**PLANNING COMMISSION REPORT
NON-PUBLIC HEARING ITEM**

**ITEM NO. 7E PRELIMINARY PLAT FOR LANGSTON COMMONS; BOB BILLINGS PKWY
 & LANGSTON WAY (SLD)**

PP-15-00246: Consider a Preliminary Plat for Langston Commons, located northwest of Bob Billings Pkwy and Langston Way. This subdivision includes 17.5 acres for neighborhood commercial development and 48 lots for residential development. Submitted by BG Consultants, for RSR Holdings LLP and KS Secretary of Transportation, property owners of record.

Figure 2: Existing and planned sidewalk connections for Langston Commons Subdivision and Langston Hughes Electuary School

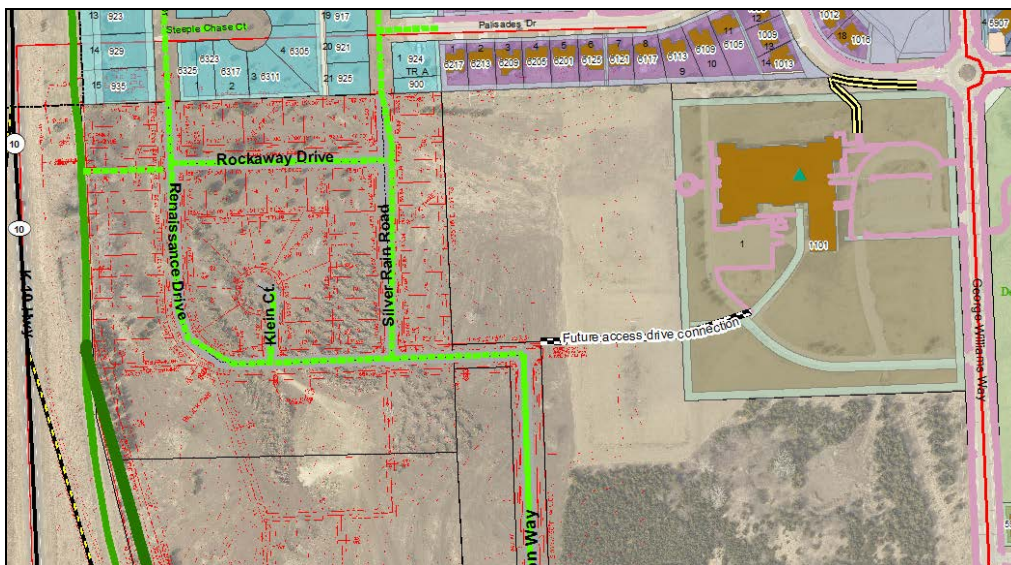
A comment provided by the public suggested that the development be required to provide a connection between the proposed subdivision, Langston Commons and the elementary school. Staff has also consulted with the School District regarding plans for the undeveloped property surrounding the school. The area located west of Langston Hughes Elementary School is currently used as an outdoor field. The distance between the south side of Palisades Drive and the north side of Renaissance Drive is just under 800'. Extending a pedestrian connection mid-block would result in bisecting the play field and creating inefficient use of the space for the school.

A planned connection to the school will be provided with the construction of an access driveway from Renaissance Drive to the school property with a sidewalk in the future. This improvement is estimated by the school district to occur in the 2017 budget year. The planned sidewalk would provide the connectivity between the proposed residential subdivision and the school property in a manner that facilitates pedestrian use and does not conflict with future use of the school property.

PRELIMINARY PLAT

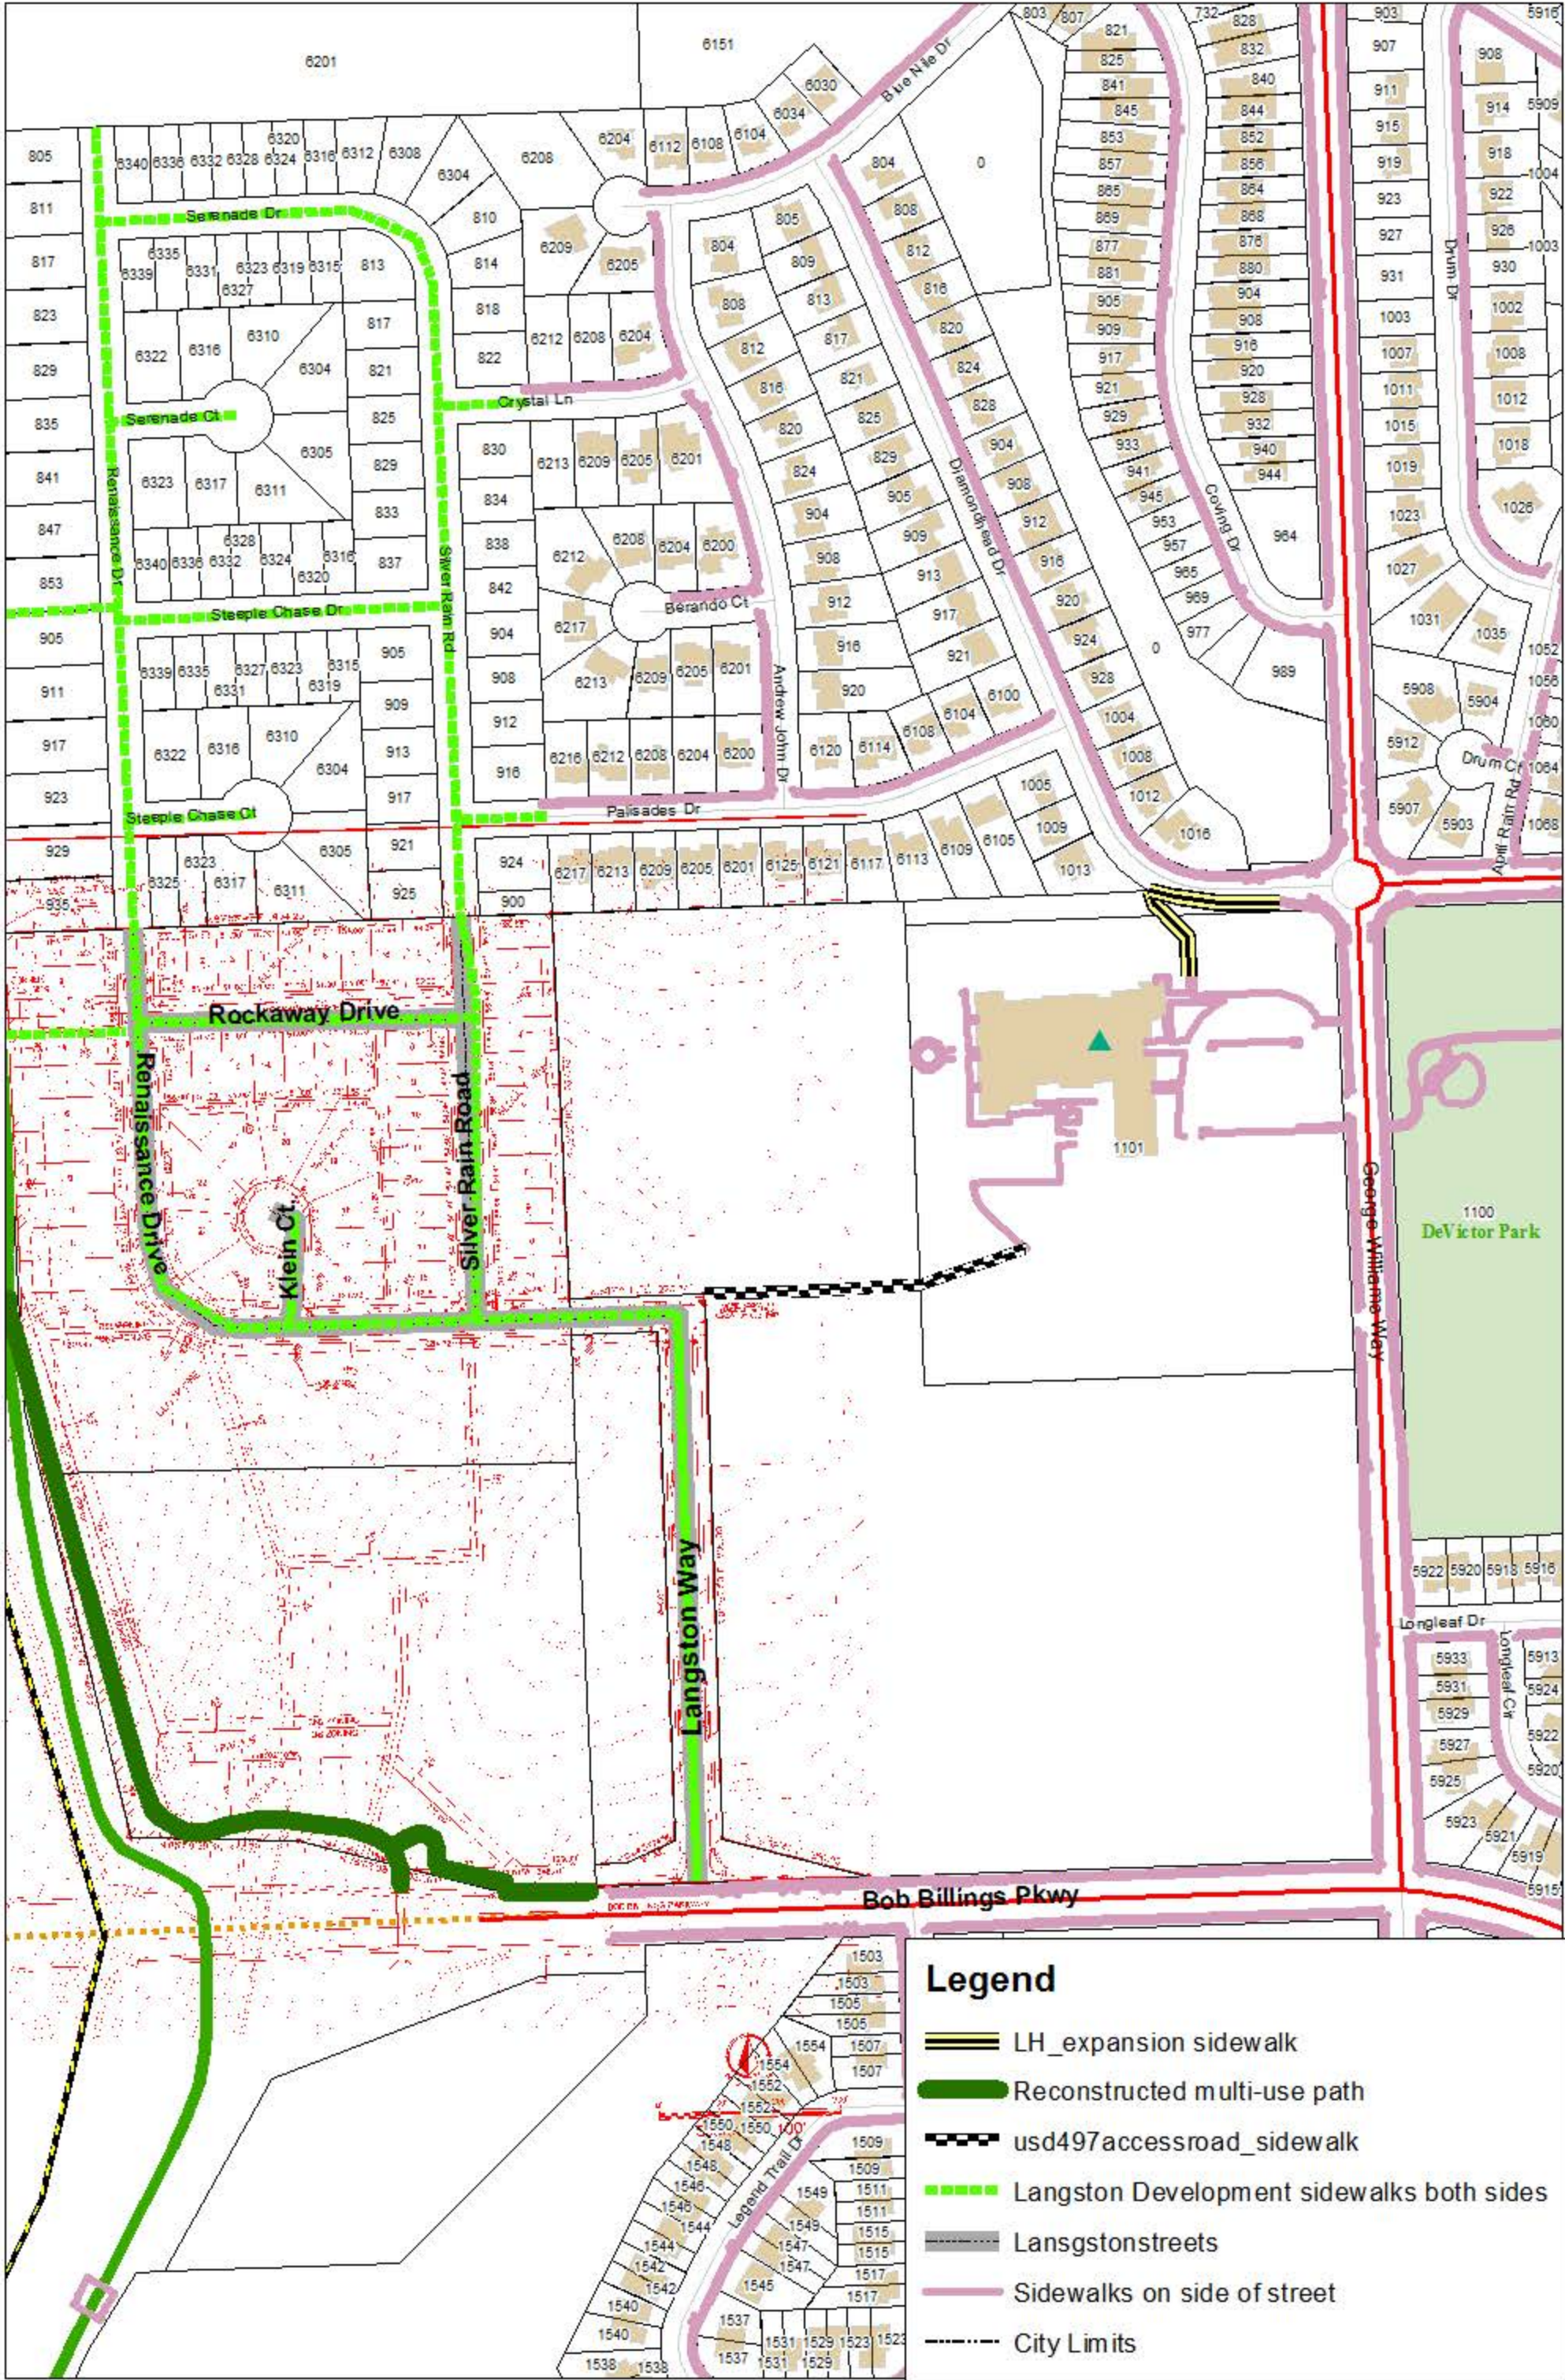
Plat described in this agenda item does not provide direct pedestrian access from new residential lots to LHES from the west. Only access envisioned is to be provided by future USD 497 Capital Improvement Plan Project from southeastern-most vertex of the residential portion of the parcel at Klein Drive and Langston Way intersection onto LHES property. Apparently the USD 497 project remains in conceptual, pre-design stage. Completion is not assured due to litigation arising from school funding political disagreements at the state level. In any event, this USD 497 potential project will not provide direct pedestrian access except for those lots near Klein Court cul-de-sac.

Plat described in this agenda item contains a local street block length of more than 800' along Silver Rain Drive south of Palisades Drive and north of Klein Drive. *Lawrence Land Development Code* (Subdivision Design Standards) requires pedestrian easements in such cases to provide pedestrian connections between the neighborhood and the school. Before approving this agenda item, the Commission must address this shortfall.

I urge the Planning Commission to approve this submission only with the design change to provide a pedestrian easement across the Block 3 lots and the following condition: Developer construct a 10' wide, ADA-compliant pedestrian walkway upon the easement to abut the west edge of the LHES site. Further the condition should specify, the azimuthal alignment of this walkway should project eastward to align with the western courtyard of LHES building.

Additionally, the Subdivision Design Standards (specifically Article 8, Section 20-810(d)(2)(i)) defines block length from "centerline to centerline of streets." (page 63) Therefore, the statement "The distance between the south side of Palisades Drive and the north side of Renaissance Drive is just under 800'." is consistent with the relevant preliminary plat and Diamondhead Final Plat documents. Unfortunately, in my view, this statement does not accurately describe the relevant block length. To calculate the block length one must add lot line to right-of-way centerline lengths on both the north and south ends which adds 60 feet. Therefore, I calculate the block length from the centerline of Palisades Drive to the centerline of Renaissance (or Klein?) Drive as 827.78 feet. (Calculation detailed below.) As I have pointed out in my earlier comments, there is no intervening

pedestrian easement permitting construction of a pedestrian walkway in this block (Langston Heights Addition Block 3) directly connecting residences to USD 497 property.

Because the block length is greater than 800 feet and no pedestrian easement is documented in the submittal your staff report concluding conformance statement appears to be incorrect when it states: "The preliminary plat is in conformance with the standards and requirements of the Subdivision Regulations and the Development Code." As I have documented above, this conformance statement does not appear to be true and should be changed accordingly.

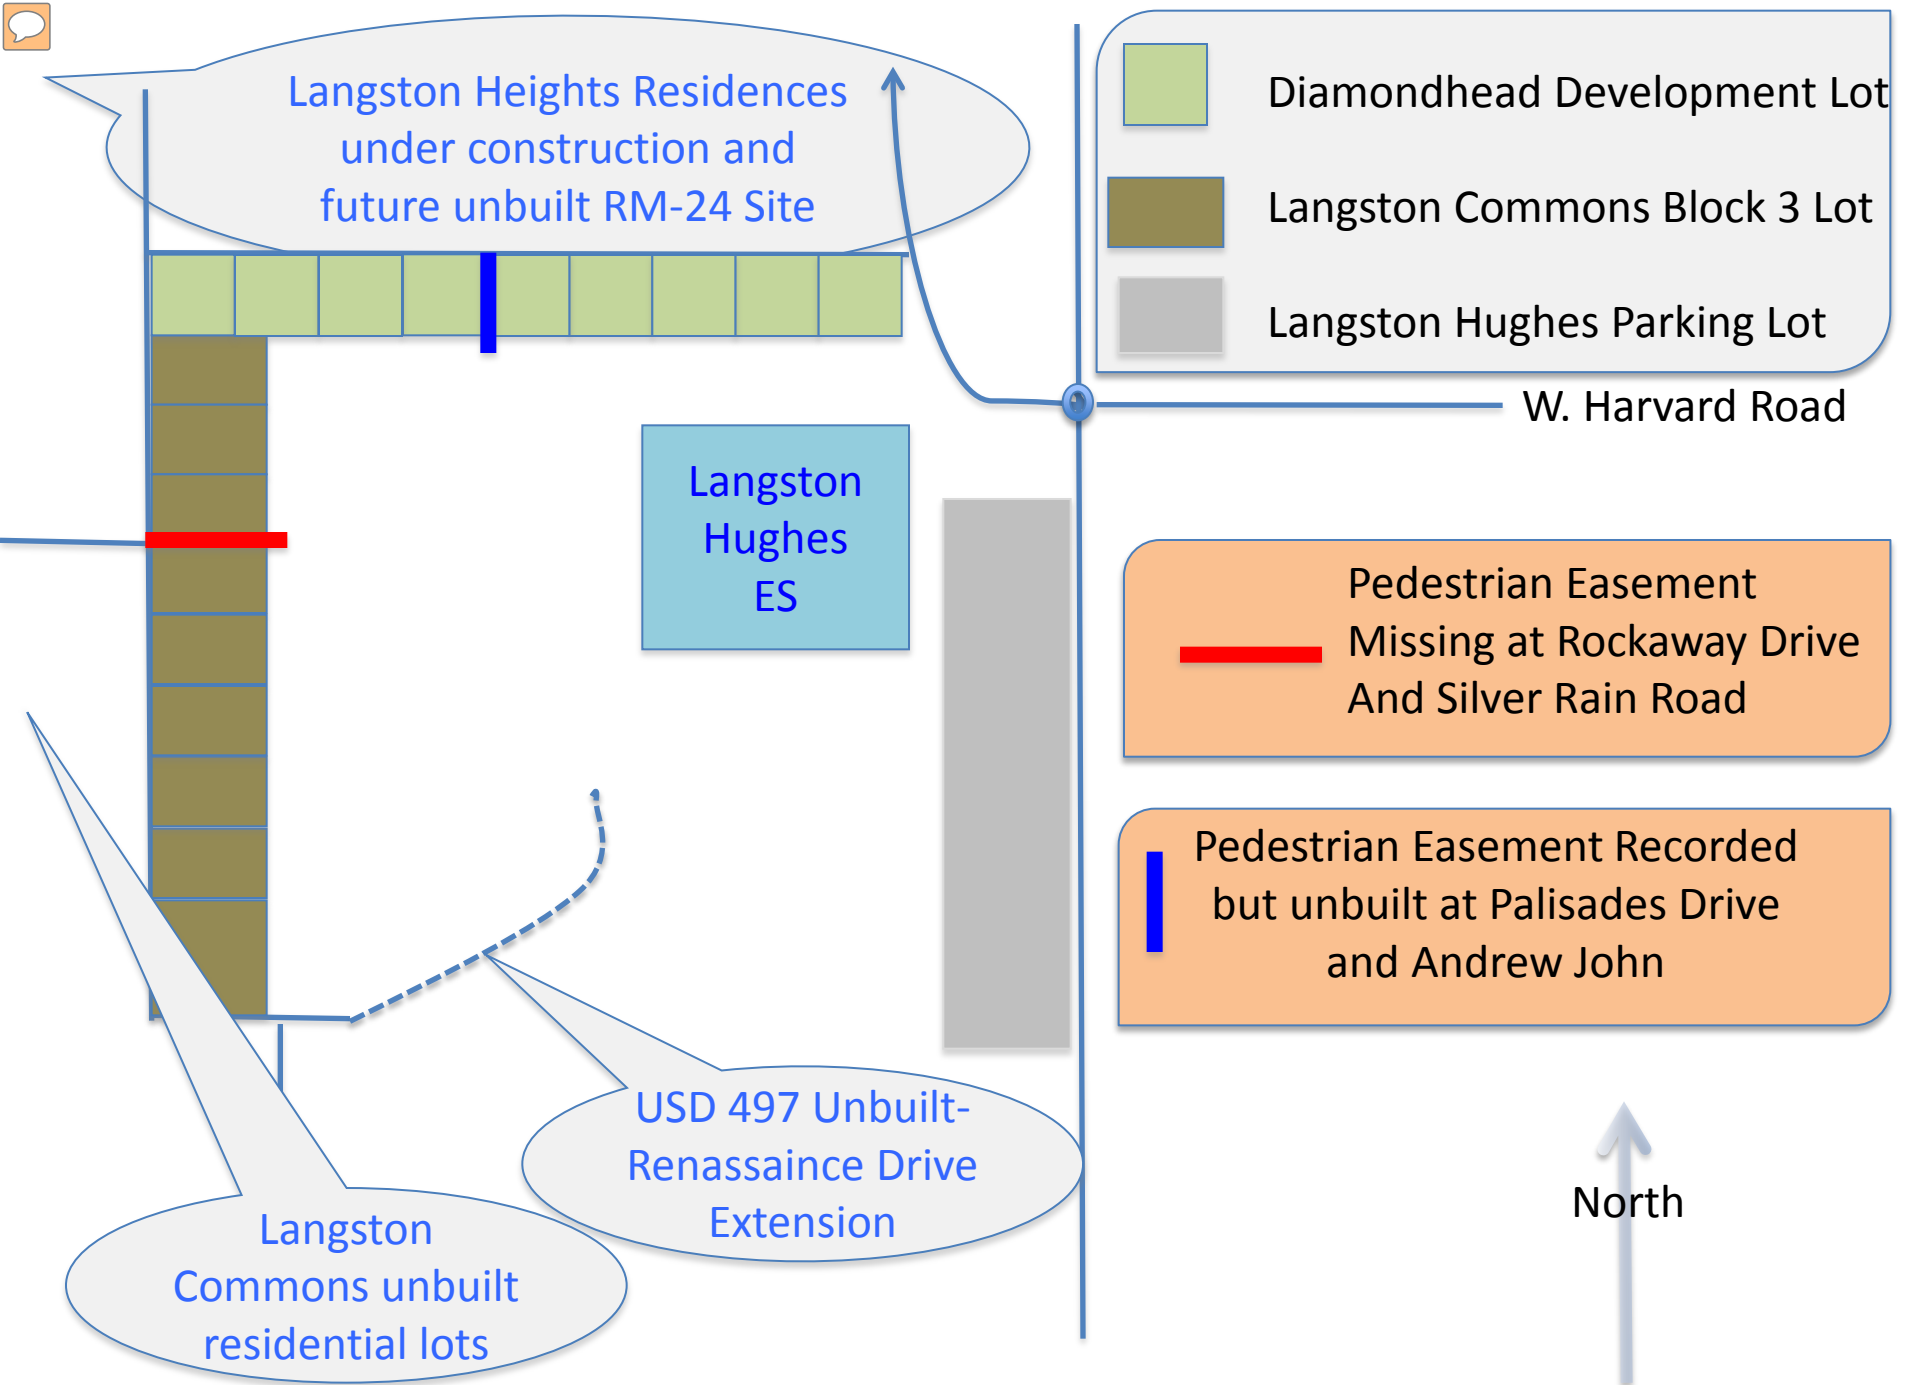
Unless pedestrian easements shown are built, school children residing in RM 24 apartments, Langston Heights, and Langston Commons will have no direct walking path to school

This violate Transportation 2040 Chapter 5, Table 5.5

Requested rezoning does not comply with Transportation 2040 plan and should not be approved absent additional pedestrian easement and sidewalk provided at Rockway Drive and Silver Rain Road intersection east to USD 497 boundary

Unbuilt pedestrian easement at Andrew John and Palisades needs to be built to provide proper elementary school level of service

No exceptions to Lawrence Complete Street Policy Section 5 paragraph (b) exist that would preclude the construction on either pedestrian easement shown.
